**SECTION 00 9111
ADDENDUM NUMBER ONE**

DATE: JULY 28, 2025

PROJECT: IOWA STATE FAIR – SWINE-CATTLE BARN UPDATES – PHASE 1

ARCHITECT: KEFFER/OVERTON ARCHITECTS

SWINE BARN
(EAST RESTROOM)
SITE PLAN

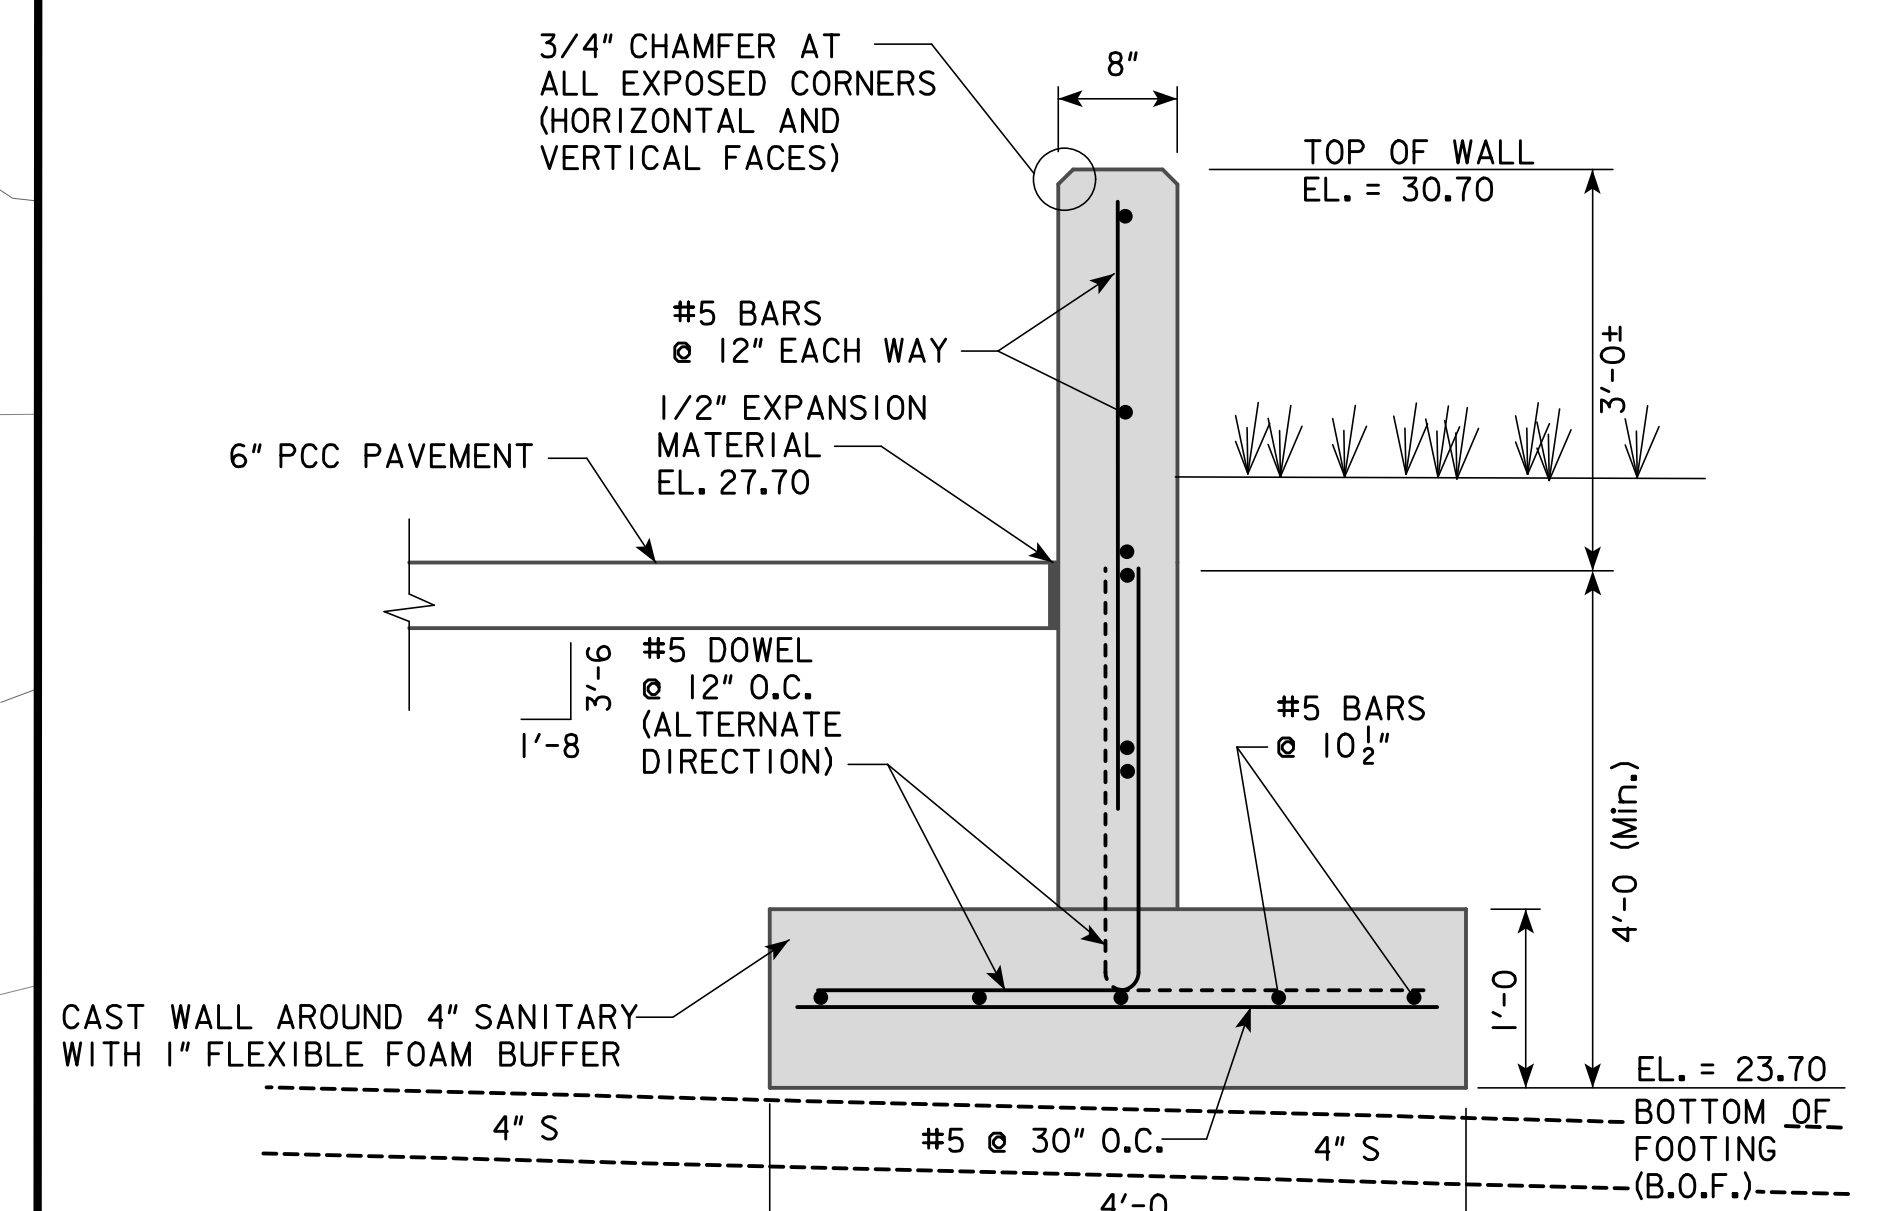
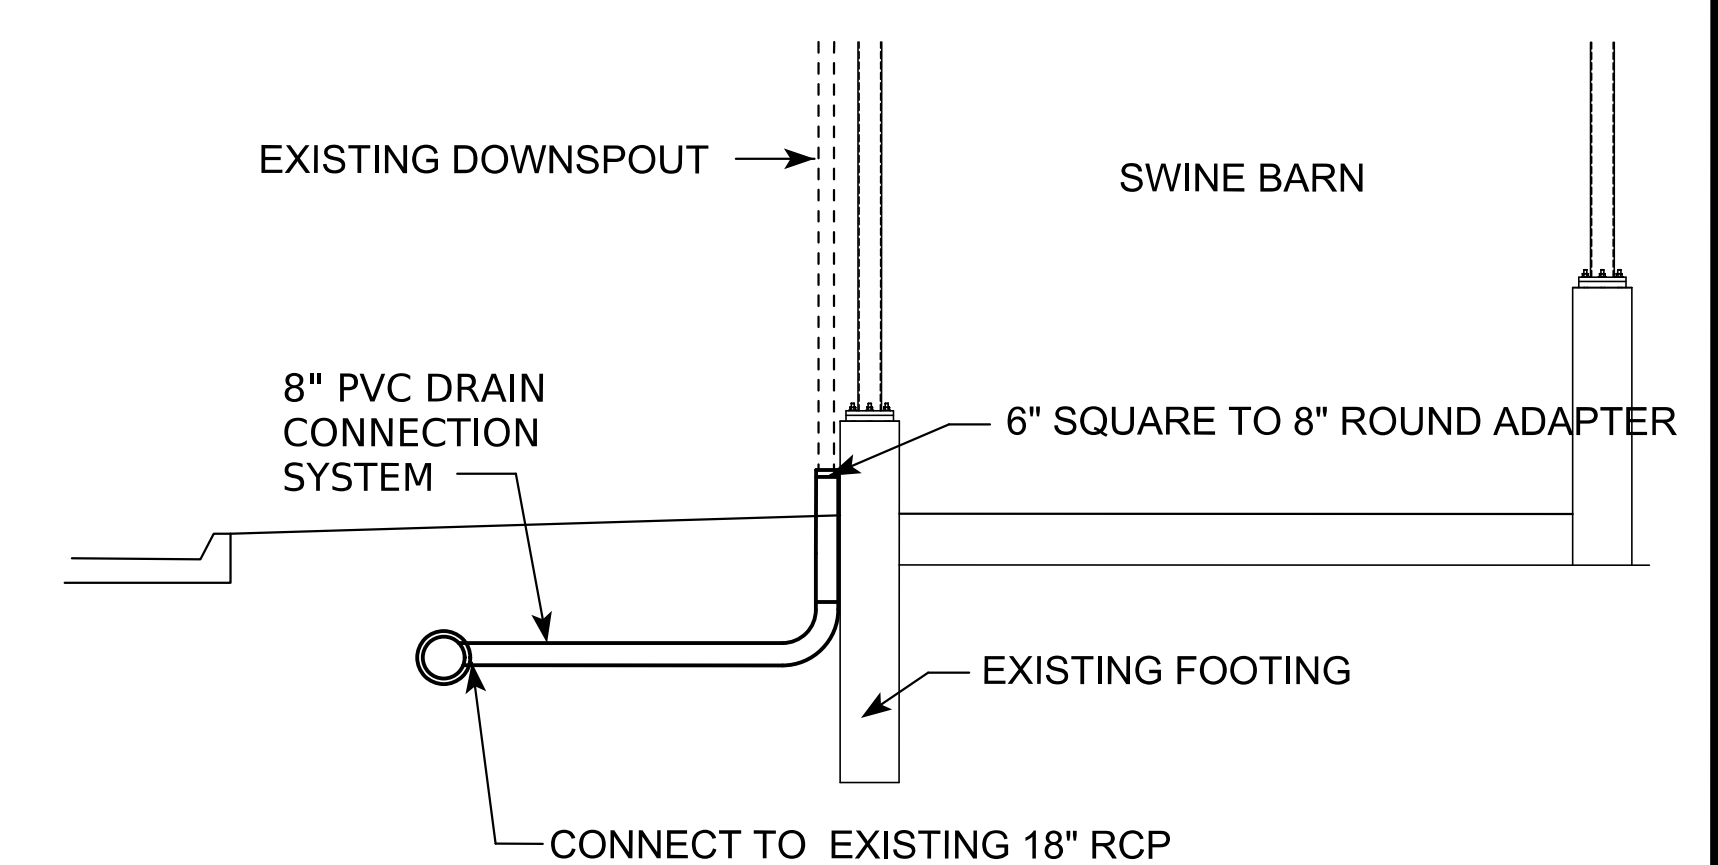
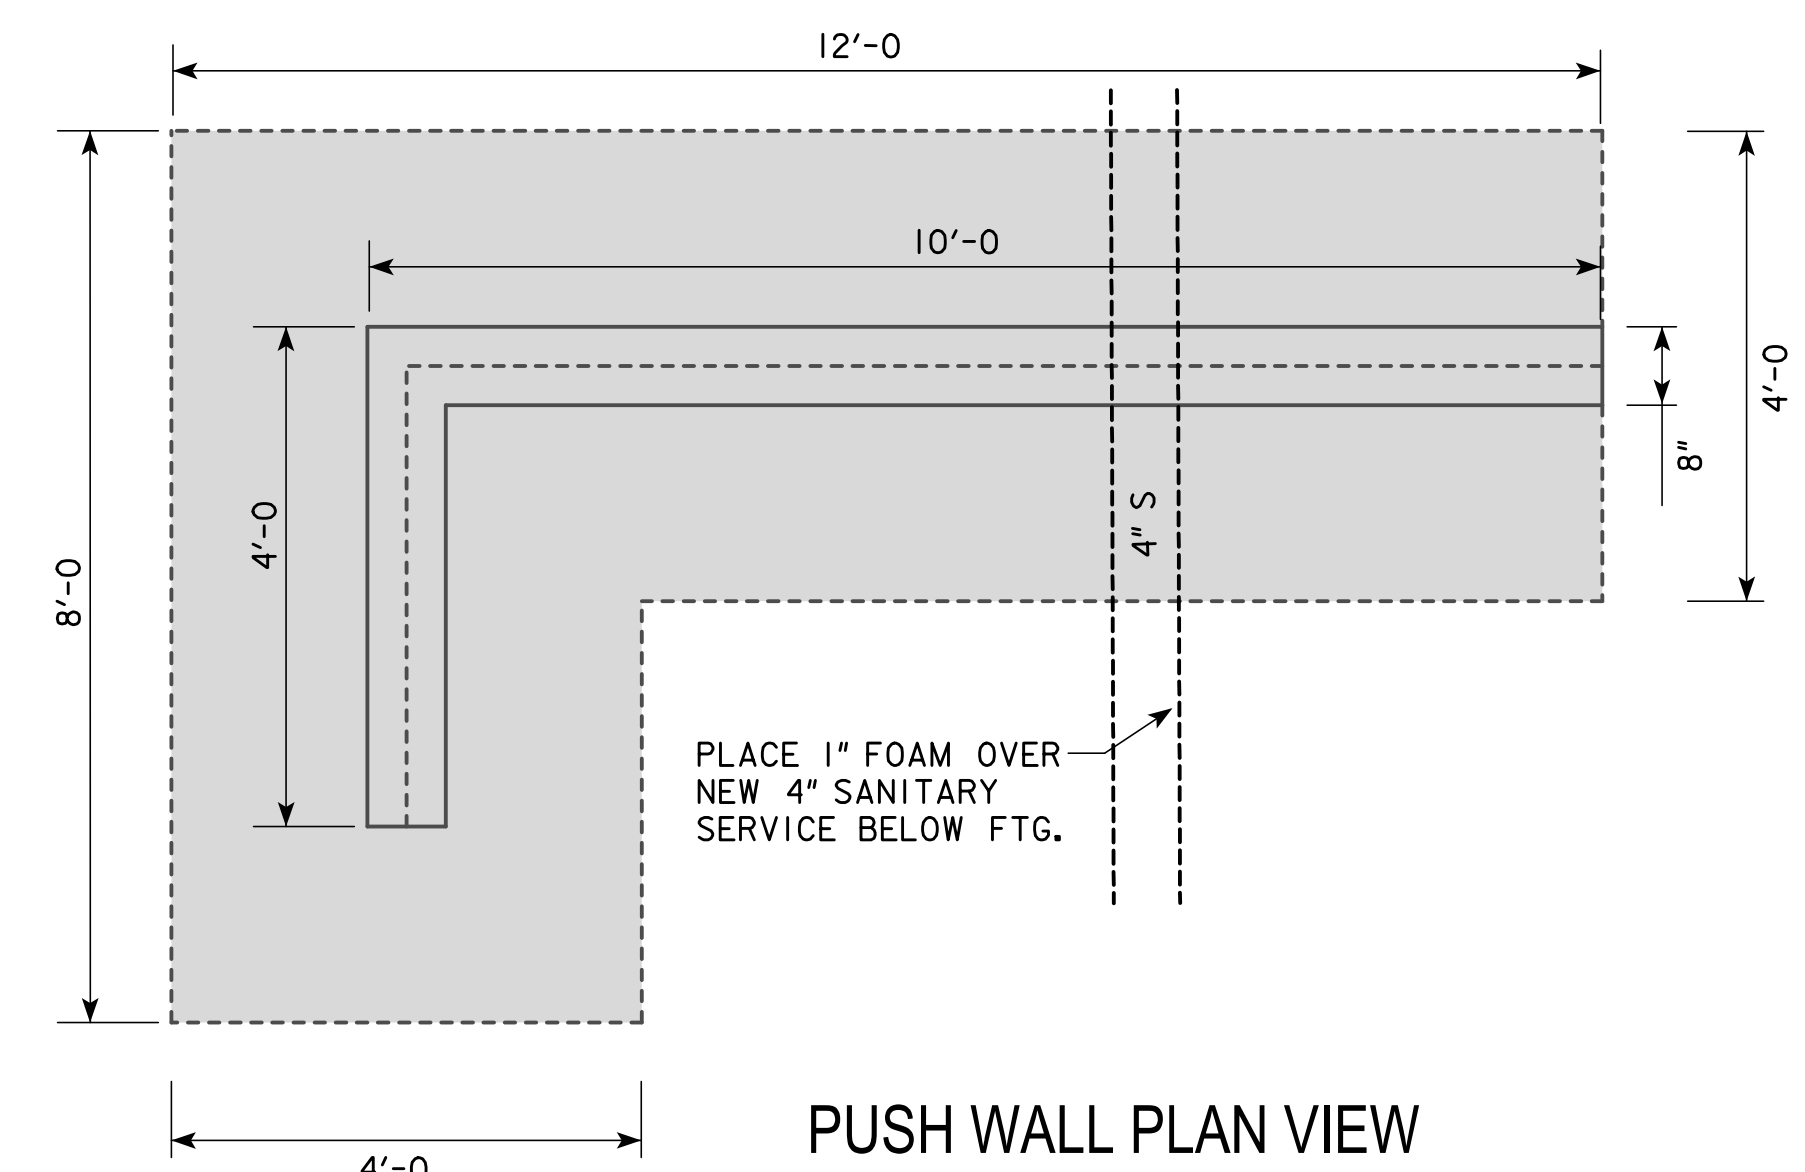
- A. SHEET C100-1 - SITE PLAN (EAST RESTROOM) SWINE BARN (Refer to revised sheet.)
 - 1. The paving in the north part of the site was identified as 8" PCC paving.
- B. SHEET C101-1 - SITE PLAN ELECTRIC BUILDING CATTLE BARN (Refer to revised sheet.)
 - 1. A new 4" sanitary service and manhole were added, along with 142 LF of sewer televising and locating. This increased the amount of pavement removal and replacement. The contractor may also estimate the cost of completing new 8" PCC paving in lieu of the 3" Mill & Fill. This additional work will include pavement removal, core out, subgrade preparation, and paving with CD baskets and tie bars. This price is requested as part of the submittal package but will not be a determining factor in the award. The PVC storm roof drain line was also upsized from 8" to 10" PVC.
